EL PASO COUNTY HEALTH DEPARTMENT
COLORADO SPRINGS, COLORADO

SEWAGE DISPOSAL INSPECTION FORM

PERMIT

APPLICATION FOR A PERMIT TO CONSTRUCT, REMODEL, OR INSTALL A SEWAGE DISPOSAL SYSTEM

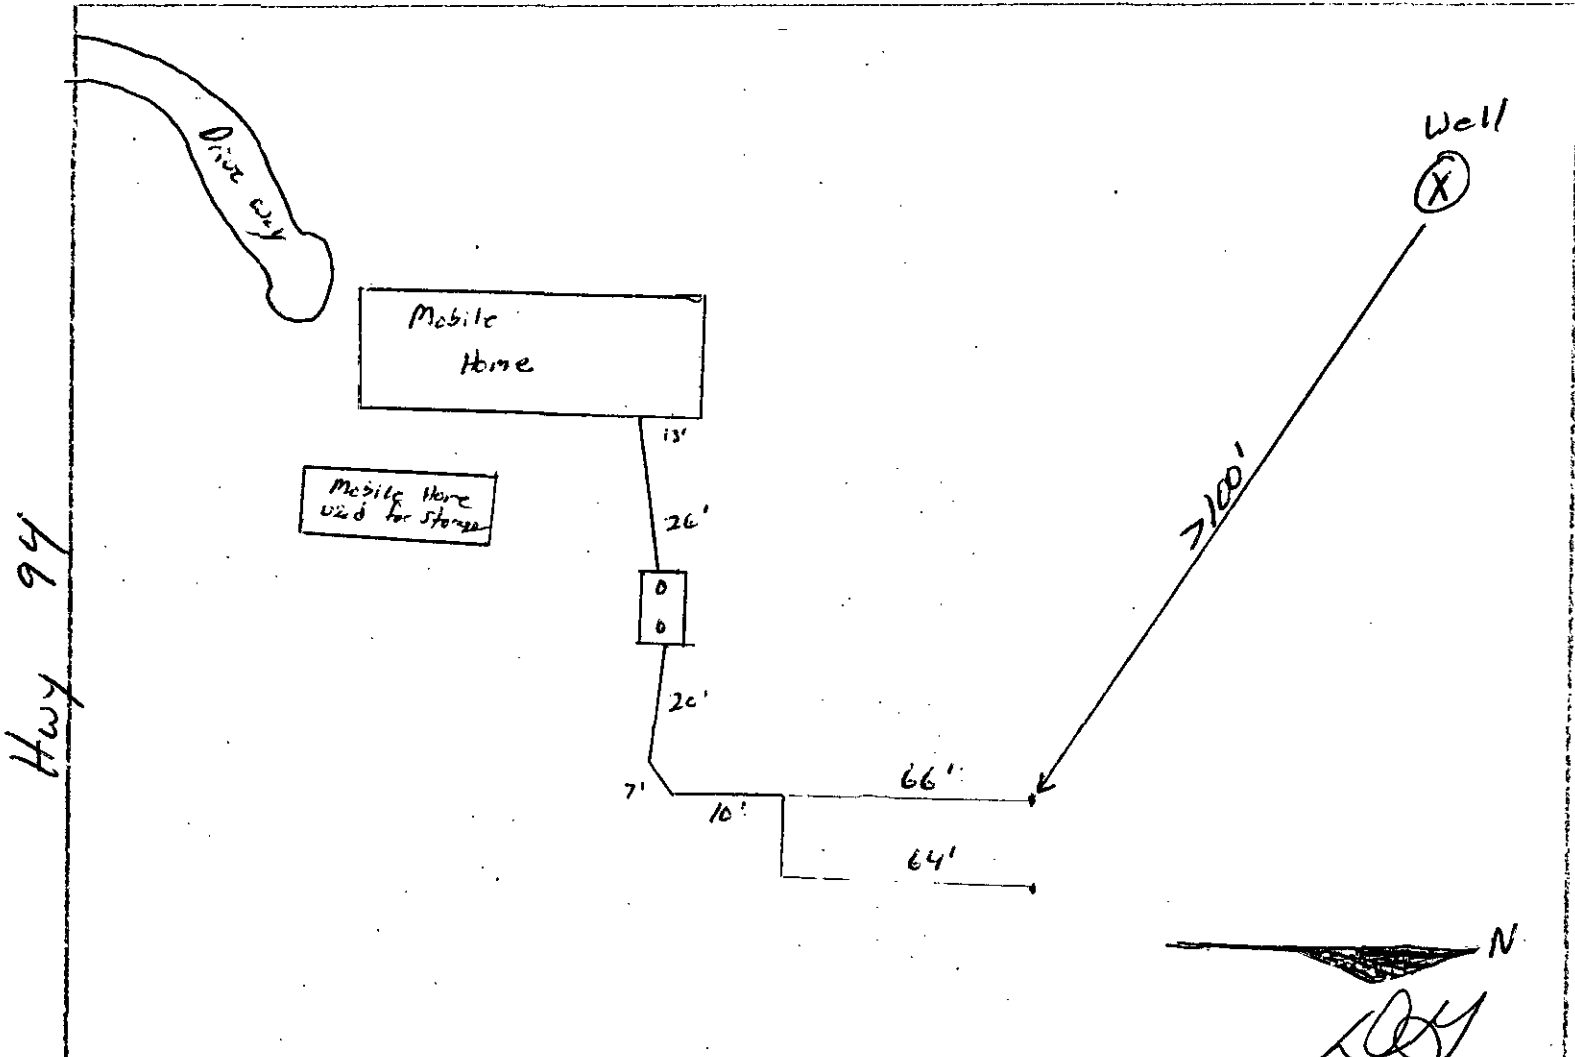
NOTES: All minimum distances must be met. Plot plan shows two trailers on one septic. Natural drainage through the center of property. Keep system 50' min. from the drainage area.

REMARKS: All minimum distances must be met Plot
plan shows 2 trailers on one septic. Property
is ^{unzoned} zoned. Natural drainage through the center
of the property. Keep system 50' min from the
drainage area. 125 linear ft of 36" trench
